DOCUMENT CHANGE REQUEST

DCR number 558	Changes required for: N/A	Originator: Olivier Masson
Date: 2009/12/02	Date sent: 2009/12/02	Organisation: CNES
Status: IMPLEMENTED

Title:	Accessories for Connectors Microminiature 3401/029, 3401/077 and Connector Savers 3401/041		
Number:	3401/032	Issue:	3

Variant 10 - Screwlock Assembly for Connector Savers

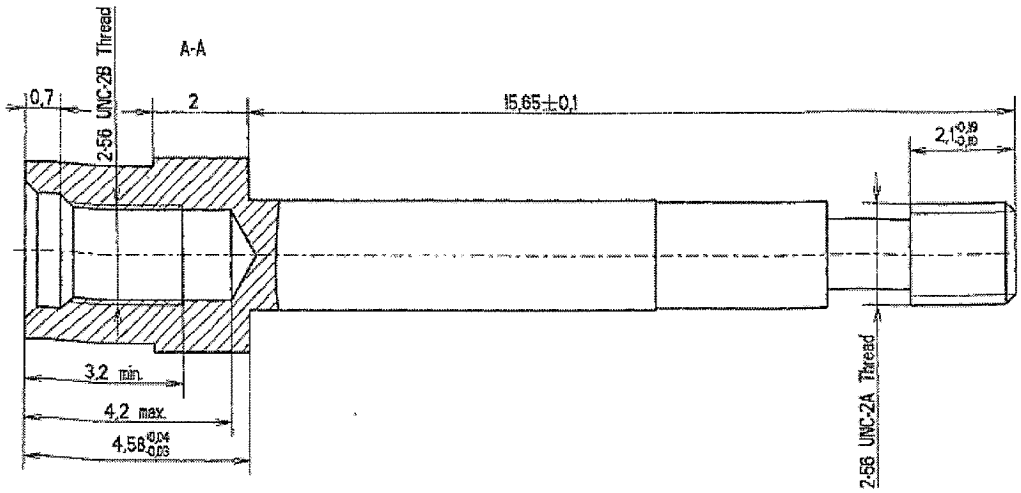
Page 10 : representation of the screwlock to be modified as shown in the attached document.

No word changing, only diameter of the screlock added on the picture and 2 diameters very similar replaced by a single one.

Design modification and simplification
Current representation with 2 diameters very similar and no value specified is replaced by a single diameter of 2.13 mini.
Modification submitted to O. Perat and approved (see attached e-mail)
